Re: Docket ID NRC-2010-0131, AP1000 Design Certification Amendment

**Comment to the proposed rule on the
AP1000 Design Certification Amendment
Docket ID NRC-2010-0131
As noticed in the Federal Register on February 24, 2011**

**Report Prepared for Friends of the Earth
By Chief Engineer Arnie Gundersen
Fairewinds Associates, Inc
May 10, 2011**

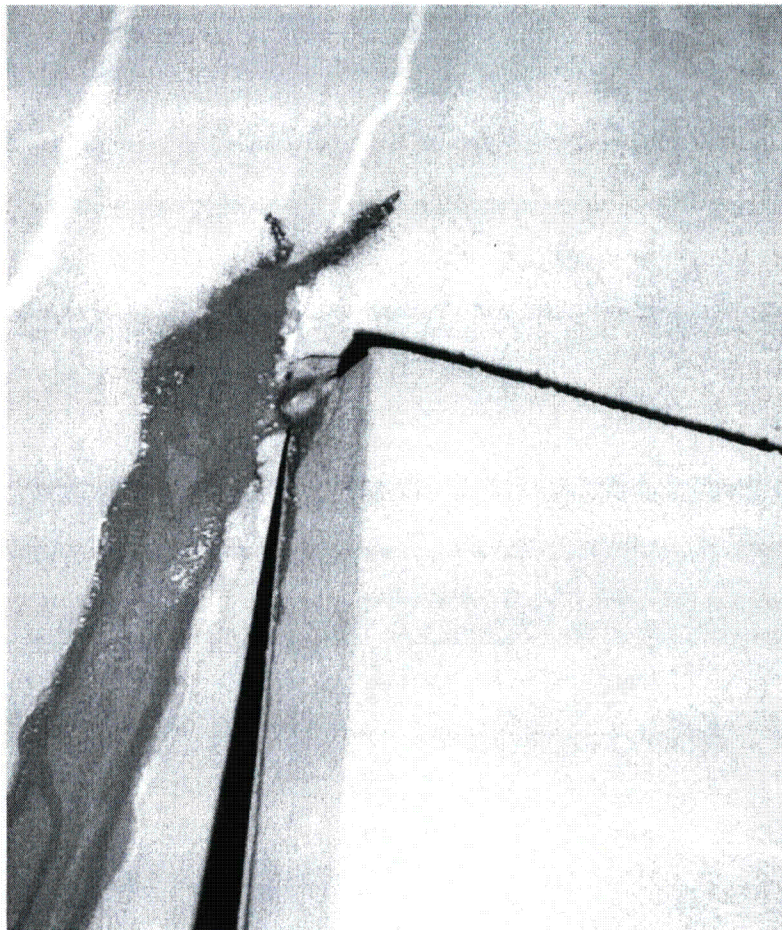
1. There are numerous instances of containment failure where rust has developed on the outside of the containment building and progressed all the way from its outside origin through the wall to the inside of the containment. None of these failures were identifiable during any visual examination until the holes had propagated completely through the containment wall.
2. There are numerous instances of containment failure at which time rust developed on the inside and progressed from inside-out all the way through the wall to the outside of the containment. Once again, these actual containment breakdowns and failures could not be identified by any method of visual examination until the actual hole had propagated completely through the

3. Fairewinds' analyses has shown that these phenomena are not just limited to through-wall rust and holes. The nuclear power industry data has numerous examples of containment failure where actual cracks have developed and propagated completely through the containment. These cracks were not identified by visual examinations, and instead were only uncovered when the actual crack propagated completely through the containment system.
